Access Compliance Report

Public Rights-of-Way

(Curb Ramps)

Intersection ID: 53390	Main Street: KELBURN_LN	Cross Street: AGNEW_DR	Location: NW
ADA ID: 32DF63A3E716	Ramp Type: BlendTrans1	Initial Pass/Fail: Fail	Overall Compliance: No
Severity Score: 1.25			
Codes/Mitigation Info/Possible Solution		Field Measurements/Component Compliance

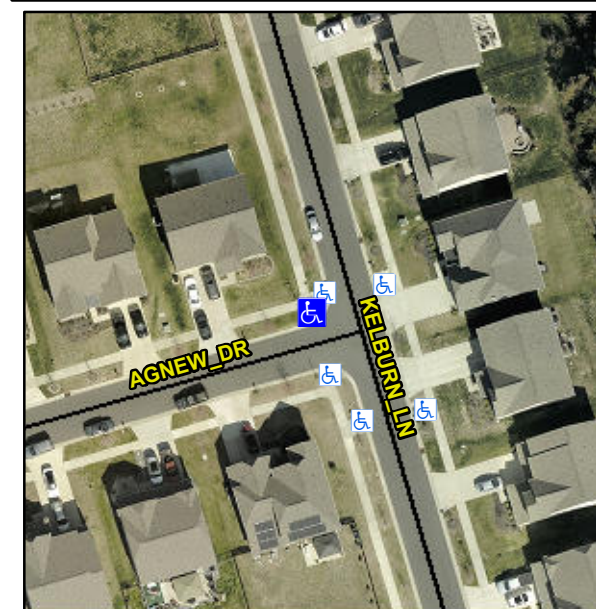
R304.5.3

Compliance	Description	Data	Compliance	Description	Data
N/A	Ramp Length (in)	97.0	Yes	BlendTrans Slope (%)	2.6
Yes	Ramp Width (in)	48.0	No	BlendTrans XSlope (%)	4.5
N/A	Flare Type LT	N/A	N/A	Flare Type RT	N/A
N/A	Flare Slope LT (%)	N/A	N/A	Flare Slope RT (%)	N/A
N/A	Flare Traversable LT?	N/A	N/A	Flare Traversable RT?	N/A
N/A	Landing Length (in)	N/A	N/A	DWS Provided?	N/A
N/A	Landing Width (in)	N/A	N/A	DWS Contrast?	N/A
N/A	Landing Slope (%)	N/A	N/A	DWS Length (in)	N/A
N/A	Landing X Slope (%)	N/A	N/A	DWS Full Width?	N/A
N/A	Landing Curb? (Y/N)	N/A	N/A	DWS Offset (in)	N/A
N/A	Shared Landing?	N/A			
N/A	Gutter Ponding?	N/A	N/A	Gutter Slope (%)	N/A
N/A	Gutter Lip Ht (in)	N/A	N/A	Gutter X Slope (%)	N/A
N/A	Painted X Walk1?	No	N/A	Painted X Walk2?	N/A
	X Walk 1 Direction	To SE		X Walk 2 Direction	N/A
	X Walk 1 Width (in)	N/A		X Walk 2 Width (in)	N/A
	X Walk 1 Slope (%)	2.7		X Walk 2 Slope (%)	N/A
	X Walk 1 X Slope (%)	4.4		X Walk 2 X Slope (%)	N/A

Remove & Replace Curb Ramp With Two New Directional Ramps or Equivalent.
